## **Connection Assessment Report for Installation of New Step-up Transformer at Decew Falls GS**

**CAA ID 2002-EX031**

Final Report

**Figure 2. Proposed Decew GS Modifications**

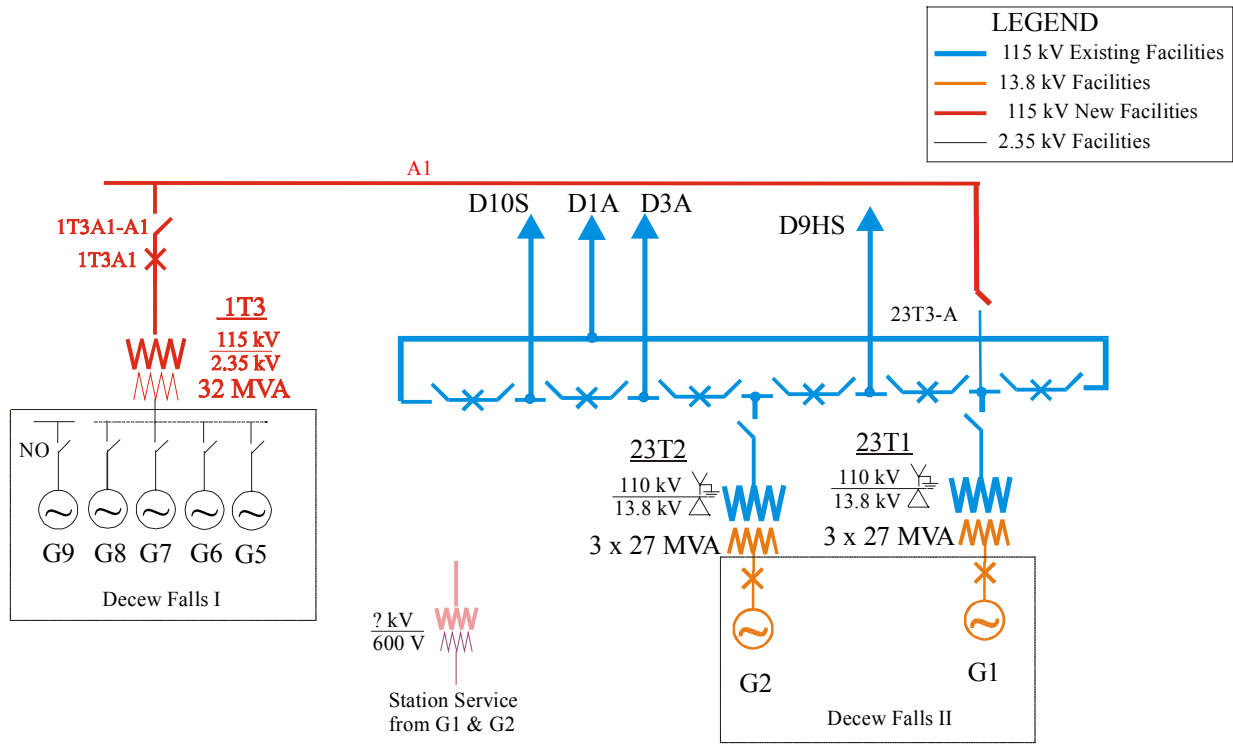
OPG has indicated that their plan includes the installation of a new 115 kV disconnect and that the existing 115 kV disconnect 23T3-A (figure 2) will also be retained. One option to be considered by OPG is to use the existing 115 kV disconnect, provided that it is adequately rated,

as the point of isolation from the IMO-controlled grid and avoid the need for the installation of a new disconnect.

It is recommended that OPG consider to use the existing 115 kV disconnect (23T3-A), provided that it is adequately rated, as the point of isolation from the IMO-controlled grid and avoid the need for the installation of the new proposed disconnect.
